Interactive comment on “A framework for assessing flood frequency based on climate projection information” by D. A. Raff et al.

Response to Individual Comments: Original Reviewer comments indicated by number. Responses to comments immediately follow.

Fig. 1. Supplemental Figure 1: Full Caption in Text

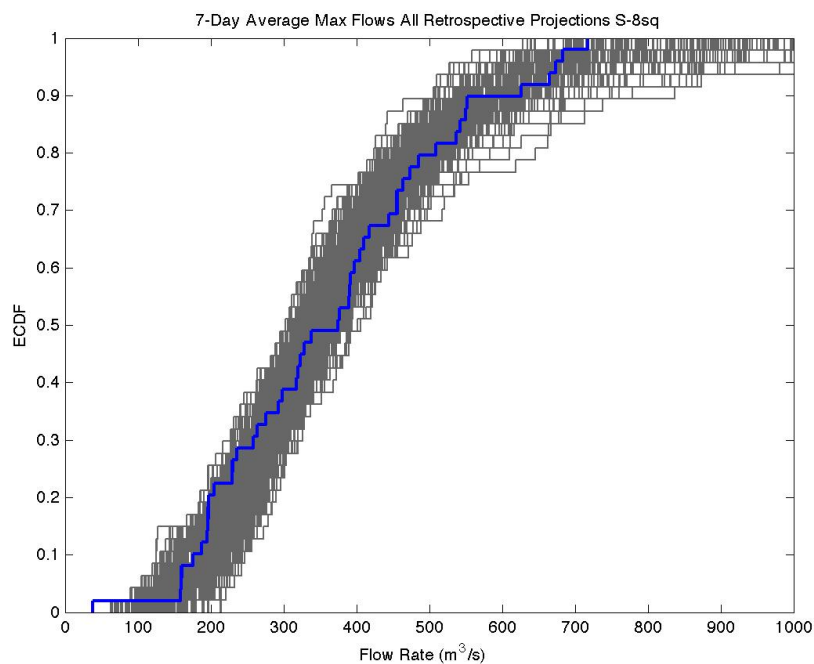
model. I see here the possibility that potentially important and presently unaccounted for model errors are being introduced in the authors analysis. This is because the precipitation and temperature data from which the forcings for the hydrology model are derived are themselves outputs from any one of several climate models. These climate models explicitly model physics at the land surface and are therefore associated with particular rainfall-runoff sequences. Moreover, the land surface parameterizations in these climate models are explicitly coupled to the atmosphere through latent heat flux that is soil moisture dependent. Correspondingly, the temperature and precipitation regimes that emerge from these climate models are associated with particular rainfall-runoff regimes that are a result of the particular representation of the physics in each climate model. The authors have treated the hydrological model used in this study as being independent of the parameterization schemes embedded within the climate models from which the hydrologic model forcings are derived and have not reported on any efforts to verify that the hydrologic model used for the flood frequency analysis yields runoff volumes that are consistent with the runoff volumes produced by the climate models.

If it is a question about whether the algorithm presented in the manuscript is able to reproduce the antecedent period and calibration period of the Sacramento model it is shown (Figure 4) that peak values are well reproduced. Reviewer Flores identifies that

volumes may be an issue as well. Here please see Supplemental Figure 1 that show that, like the peaks, volumes are also well reproduced. This figure was not included in the initial manuscript over the concern with density of information and length of the document.
